B	29 Oct 19	ECM	ECO 3
A	1 Oct 19	ECM	ECO1, ECO2
MBARI Monterey Bay Aquarium Research Institute 7700 Sandholdt Road Moss Landing, CA 95039 (831) 775-1700 www.mbari.org MBARI proprietary information (c) MBARI 2017			
Title		Schematic, Pump & Regen, Lower Half Elex, Coastal Float	
Variant		<variant>	
Size	Date:	Engineer	Sheet of
Custom	Tuesday, October 29, 2019	Mellinger	5 of 5
Design File			
Z:\CP\F\ELECTRICAL ENGR\CAD PROJECTS\EDS STUFF\LOWER HALF ELEX P2\SCHEMATICS\100221251 CPF LOWER		Schematic Name	
Schematic:HE-CPF-P2		Page Name	
		Layout File

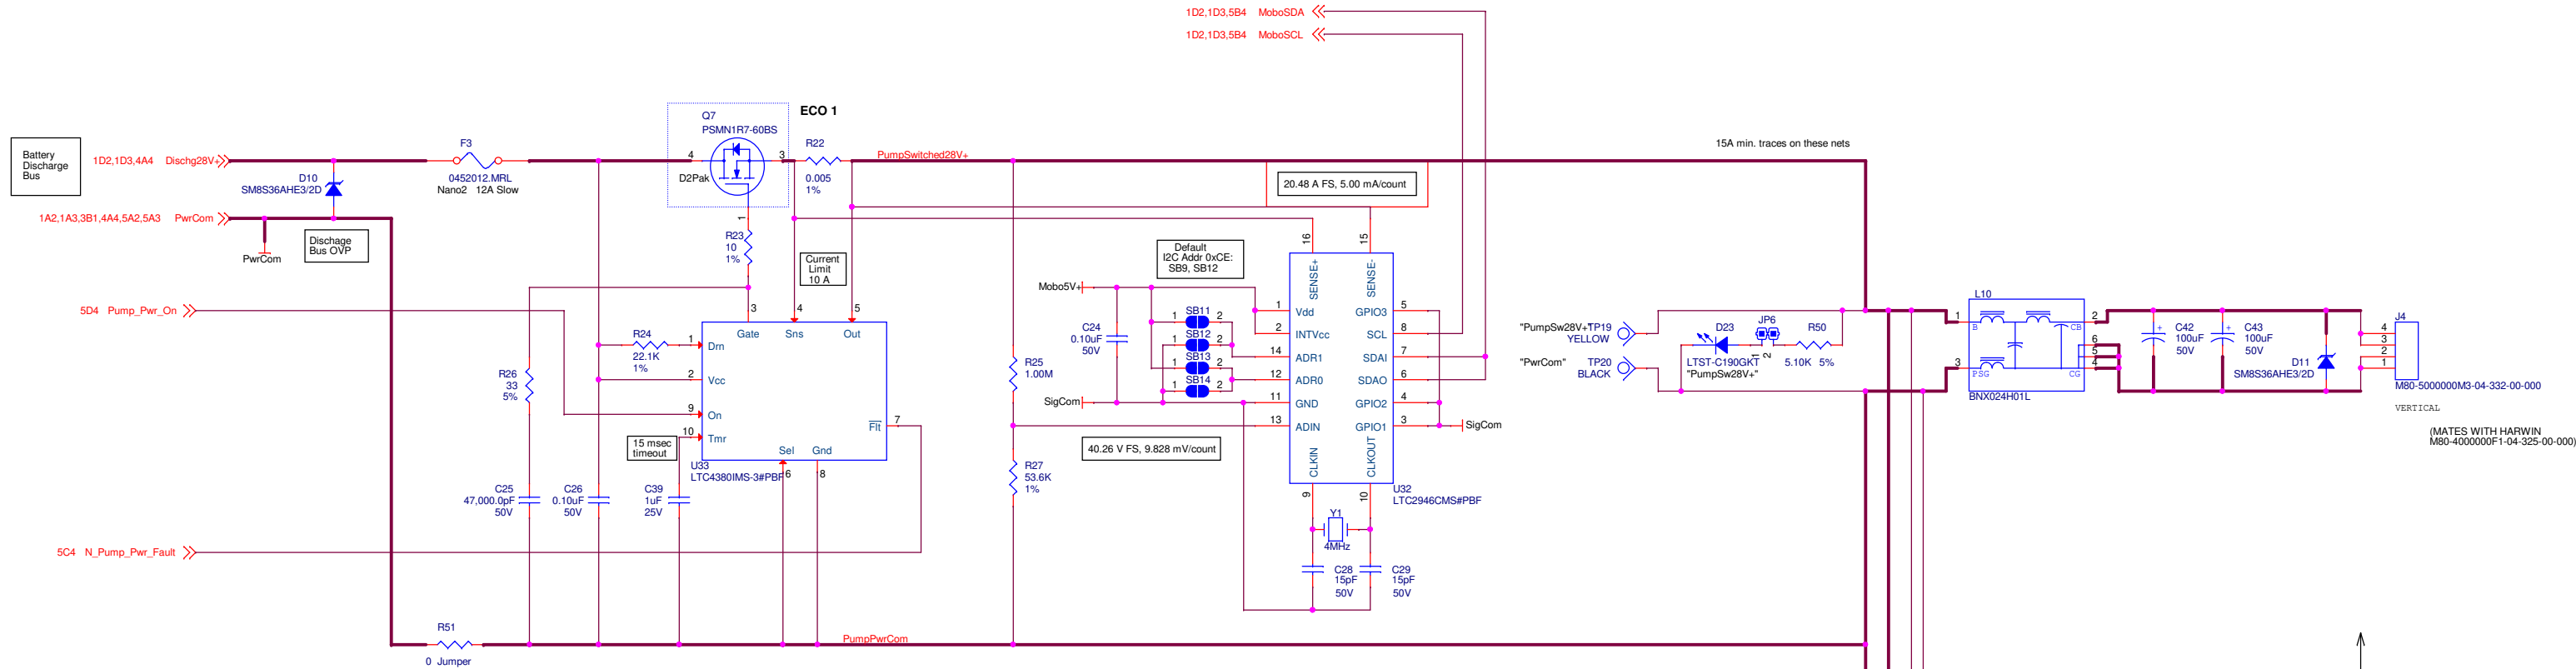
- ECOs for Schematic Rev A:**
1. Change Q7 from PSMN1R5-30 to PSMN1R7-60BS for voltage rating
 2. Remove pot R37 for clearance, and sub fix axial-lead part
- ECOs for Schematic Rev B:**
3. Add #18 AWG wire between J7-1 (PumpPwrCom) and P5-A2 (PwrCom).
